Docket Item # 7
BAR CASE # 2010-0246

BAR Meeting
September 15, 2010

ISSUE: Alterations to Previously Approved Plans

LOCATION: 615 South Fairfax Street

Figure 6. Revised plans with change from previously approved plans.

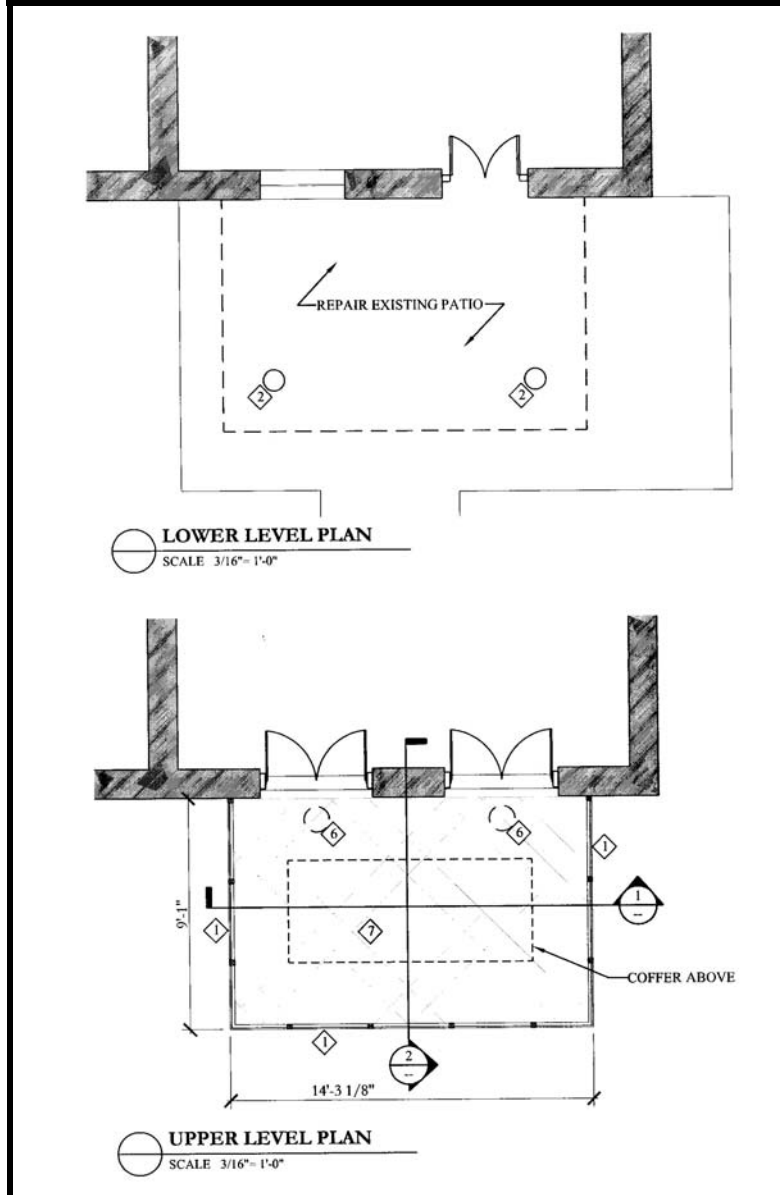
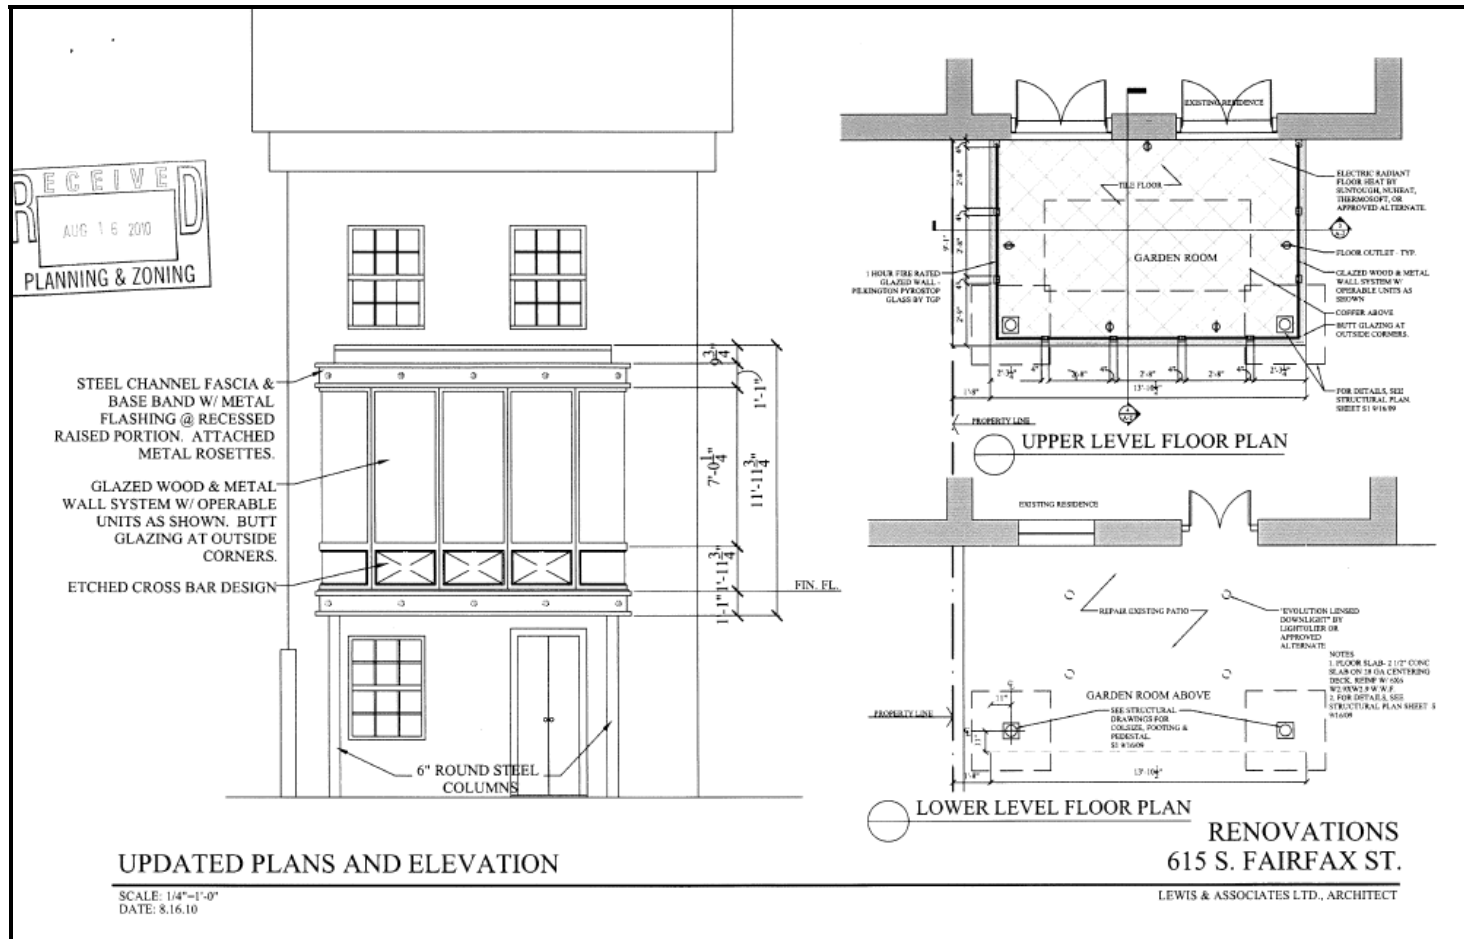
The applicant is requesting approval of a Certificate of Appropriateness to shift the location of a previously approved second story rear addition at 615 South Fairfax Street approximately 19" to the north. The previously approved addition will replace a prior sunroom addition of the same size. The addition will measure approximately 9'-1" by 14'-3" and will be supported by two 6" round steel columns. The addition will have glass on all three sides, composed of a custom made, double-insulated wood and metal wall system. The windows on the north side will now have fire-rated glass, due to proximity to the property line, but the design of the framing is unchanged. The upper and lower horizontal framing will be constructed of steel beams with attached metal rosettes. The existing at-grade patio will be repaired after the construction of the new addition.

The design of the proposed addition is unchanged in size, material or detail from the one previously approved by the Board. However, when the previous sunroom was removed during construction, it was discovered that the original fenestration on the rear of the house was not where it was shown on the construction drawings. Therefore the proposed sunroom must be shifted from 3'-0" off the north property line to approximately 1'-5" from the north property line. Unfortunately, changes to a footprint exceeding 6" or 10%, whichever is less, cannot be administratively approved by staff and this requires re-approval of the Certificate of Appropriateness by the Board. While this 19" relocation has an undeniable minor effect on the relationship of the proposed first floor sunroom to the existing windows above and below this level, this mid-block location in a rear yard will never be viewed by the public in direct elevation. Staff, therefore has no objections to the relocation, as submitted.

STAFF RECOMMENDATION: Staff recommends approval of the application, as submitted, with the following condition:
